Government of India - Ministry of Railways
Research Designs & Standards Organization
LUCKNOW - 226011

MODIFICATION SHEET No. RDSO/2008/EL/MS/0353 Rev.'0' Dated 23.01.2008

Provision of Rotary switch in the control circuit of Cab heaters and Cab fan on SIV fitted Electric Locomotives.

9.0 MODIFICATION DRAWING:

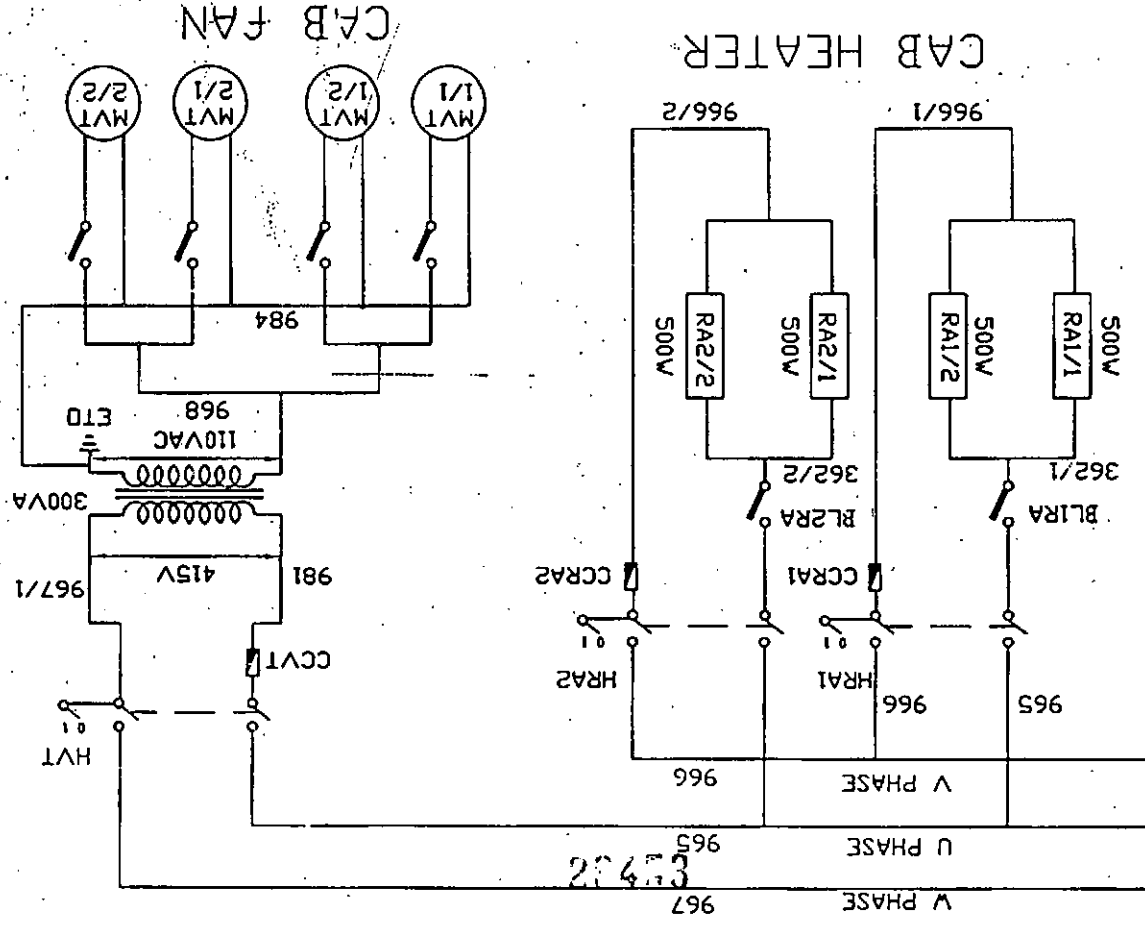
Three nos, of Rotary Switches shall be provided one each in two cab Heater circuits and one cab fan circuit as given below.

- i) HVT shall be provided on both the input side cables i.e. 'U' and 'W' phases of TFVTINV.
- ii) HRA-1 and HRA-2 shall be provided on input cables No. 965 and 966 i.e. 'U' & 'V' phases in series with CCRA-1 and CCRA-2 fuses of cab-1 heaters and cab-2 heaters.

Normally existing switches shall be used for switching ON/OFF of Cab fan and Cab Heaters, the HRA-1, HRA-2 & HVT Rotary switches being in ON position (ie position '1'). Incase of earth fault HRA-1, HRA-2 or HVT shall be switched OFF (ie position '0'). to isolate the circuits of Cab Heaters or Cab fans respectively.
